**Town of Groveland**  
**Economic Development**  
**Planning & Conservation Department**  
**Planning Board**  
183 Main Street  
Groveland, MA 01834

**CONTINUED 181R SCHOOL STREET:**

APPLICATION FOR APPROVAL OF  
A DEFINITIVE PLAN

SUBDIVISION NAME 181R School Street PLAN# \_\_\_\_\_

REVISIONS			UTILITIES & ROAD PROFILE	DRAWING NO. C-7
NO.	DESCRIPTION	DATE

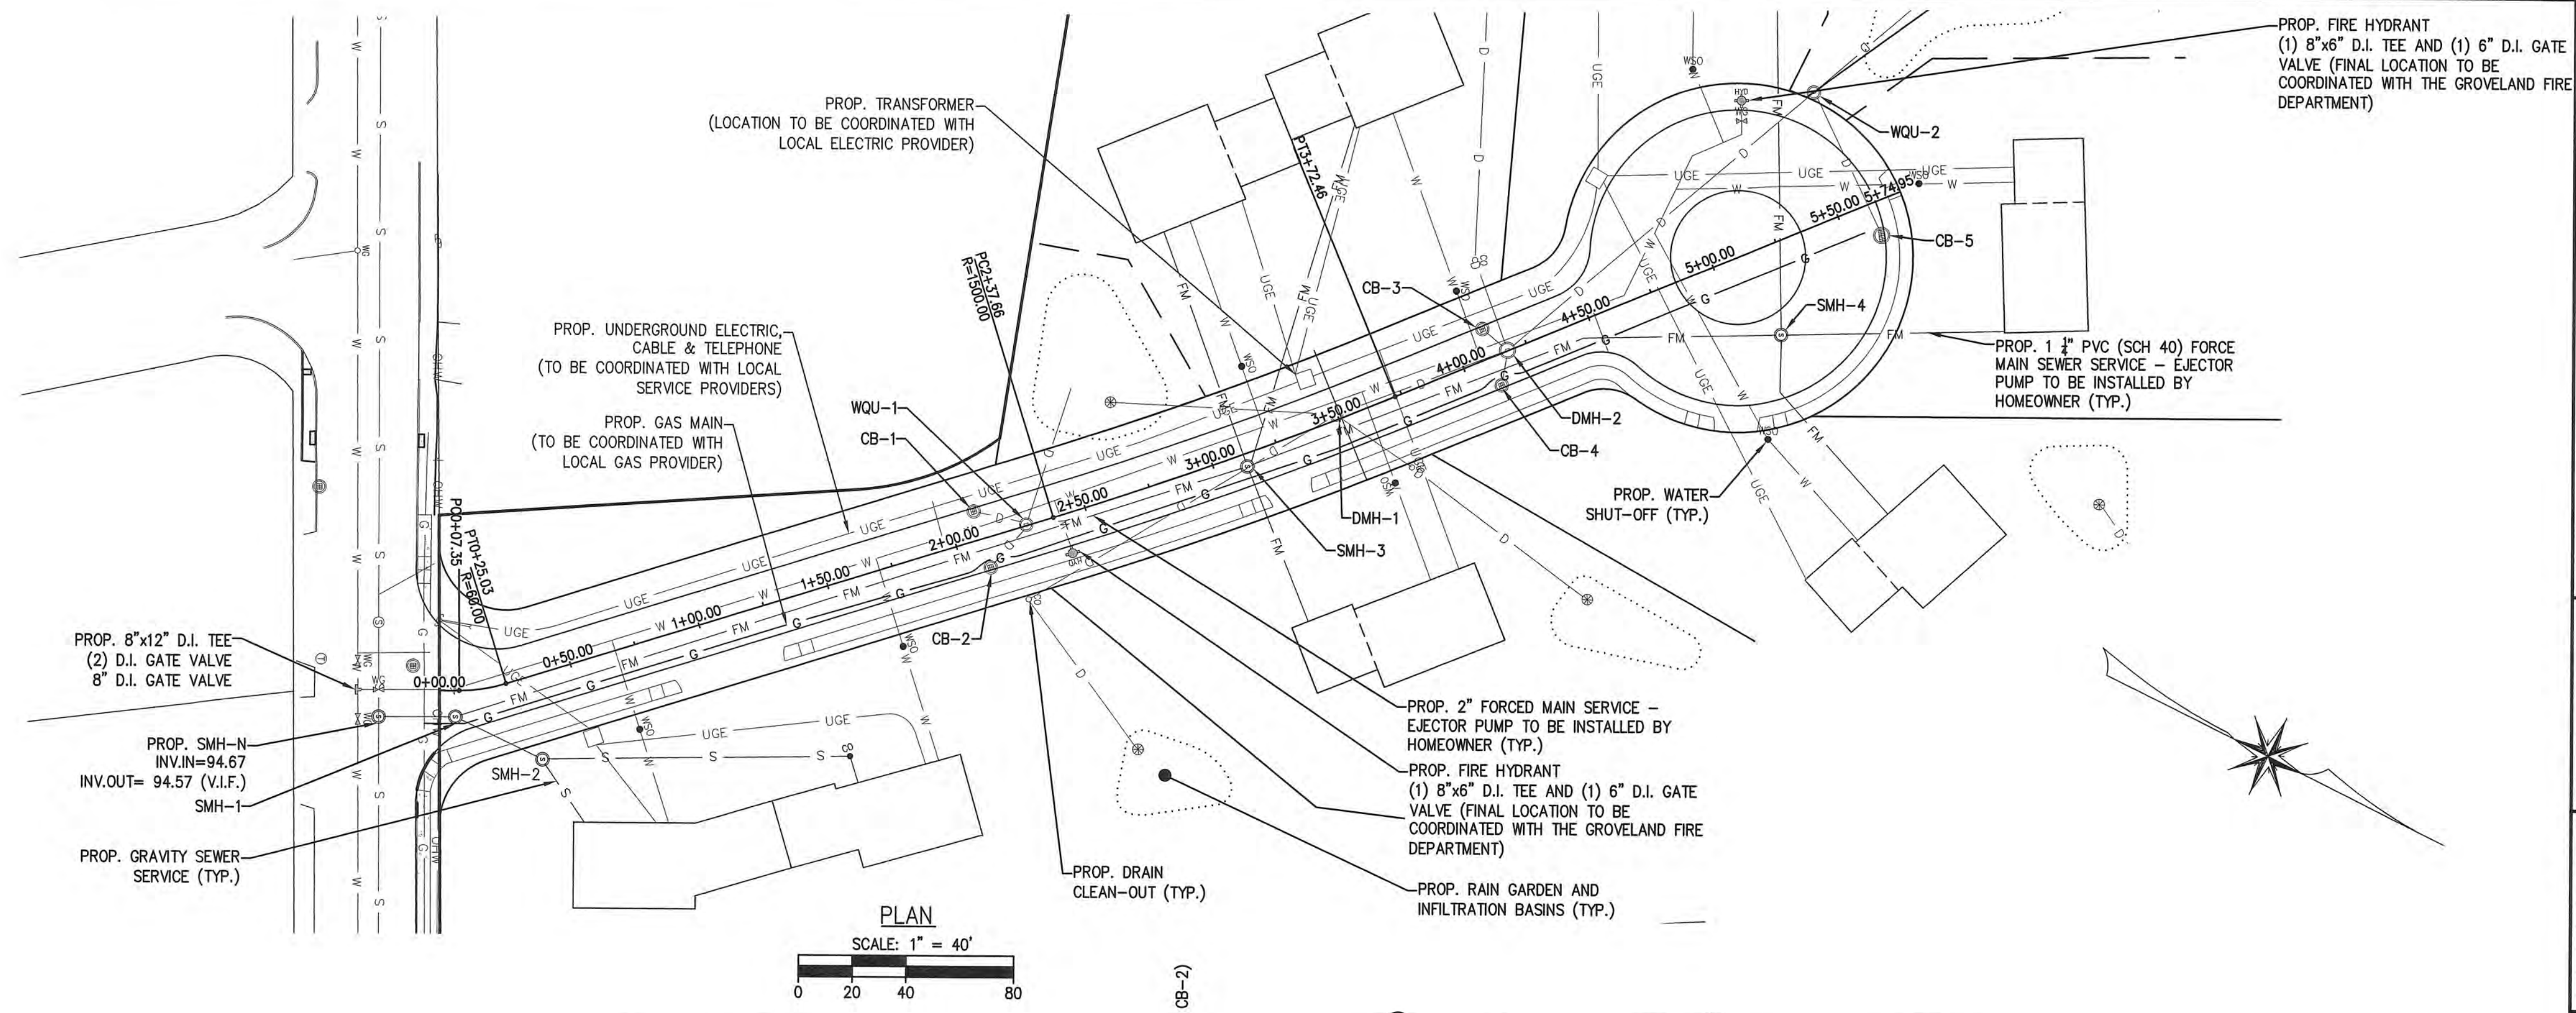
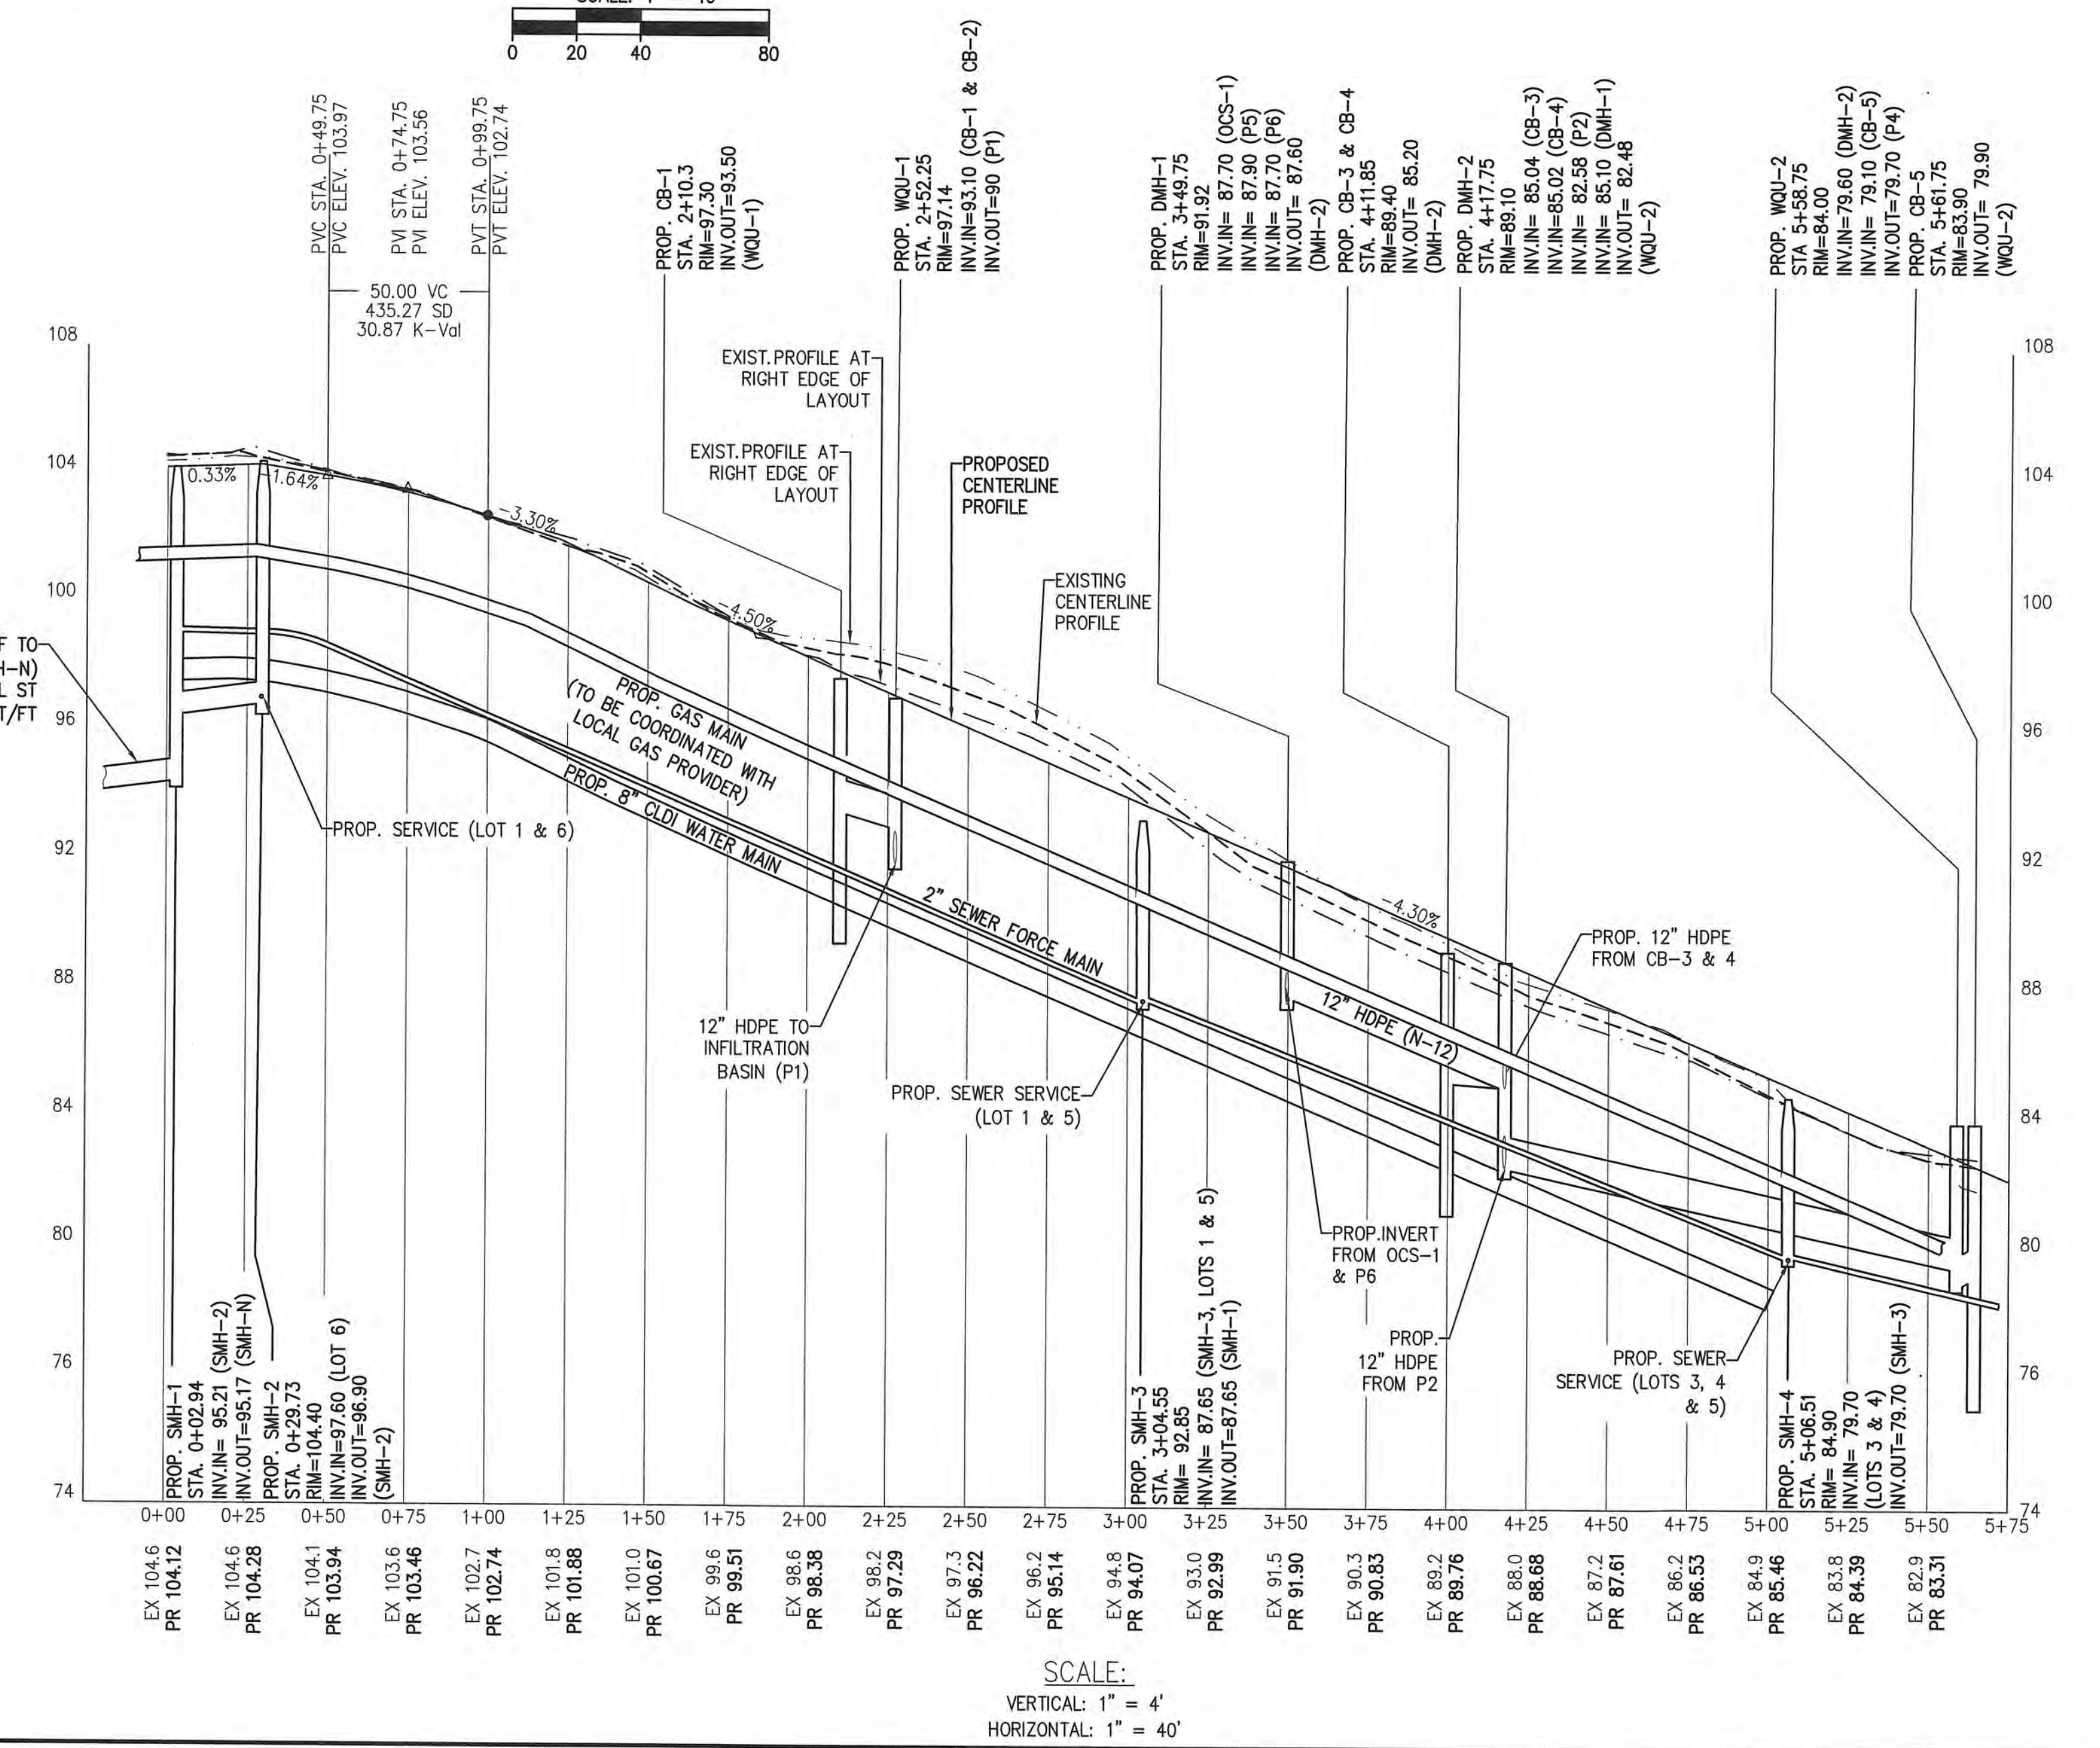
- c. On Sheet C-6, The bottom contour (elevation 97) appears to be missing from rain garden P5.
  - d. On Sheet C-7, there is no label detailing the proposed rim or invert elevation(s) for proposed catch basin 2 (CB-2).

- e. On Sheet C-7, water quality unit 2 (WQU-2) appears to have pipe inverts leaving the structure that are higher than the inverts in.
15. **14.10.C.25** – Phasing of the project should be detailed/displayed on the construction plans.

24. No rim elevation is provided for SMH-1.
25. Pipe sizing and proposed material type should be provided for the proposed sewer connection from Lot 6.
26. Two utility conflicts can be observed on Sheet C-7:
